Access Report

**40 Myoora Road**  
40 Myoora Road  
TERREY HILLS NSW

For: Gardoxi Pty Ltd  
Ref: PAA\_24008

prepared by:			
Lindsay Perry	Draft	Issued for review	7 August 2024
Lindsay Perry	Revision 1	Issued for DA	15 August 2024

Figure 2 | Site Plan (in part)

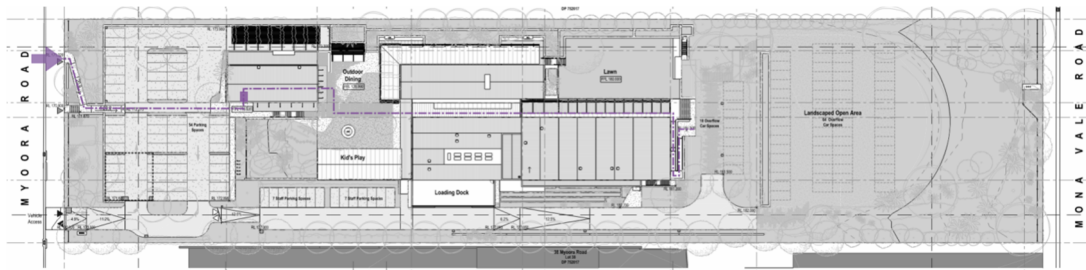
An accessible path of travel is provided to the building entrances from the allotment boundary along Myoora Road. A walkway is provided in this location.

A lift facilitates access to the building entrances from the accessible car parking that is provided within the underground carpark.
